Technical Service Bulletin

Reference: ICOM-TSB13-005	Date: 8/14/2013
-------------------------------------	---------------------------

Ford Transit Fuel Fill Hose Clamp

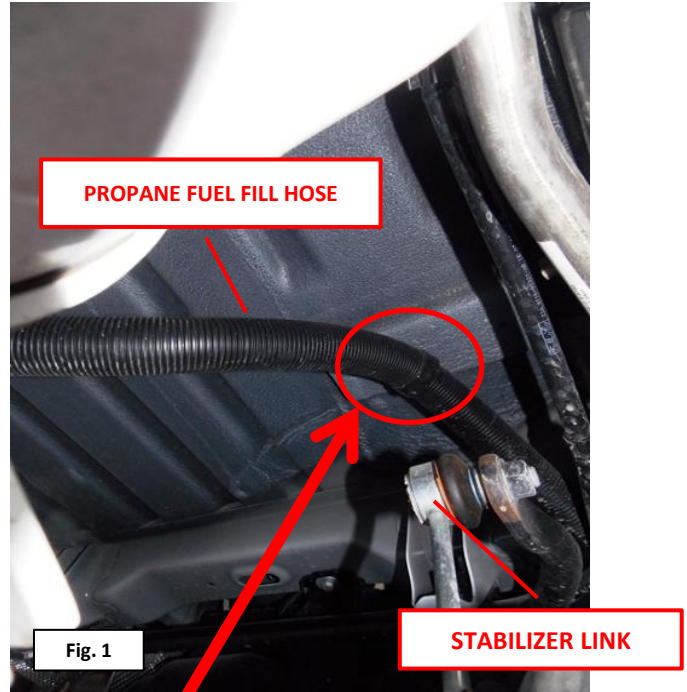
Secure the propane fuel fill hose to the floor pan above the rear axle with a 1-3/8" P-Clamp.

To avoid potential contact with the passenger side rear stabilizer link.

1. Locate the propane fuel fill hose routed above the passenger side stabilizer link. (Fig. 1)

2. Install the 1-3/8" P-Clamp onto the fuel hose and secure the clamp to the floor pan reinforcement as shown. (Fig 2)
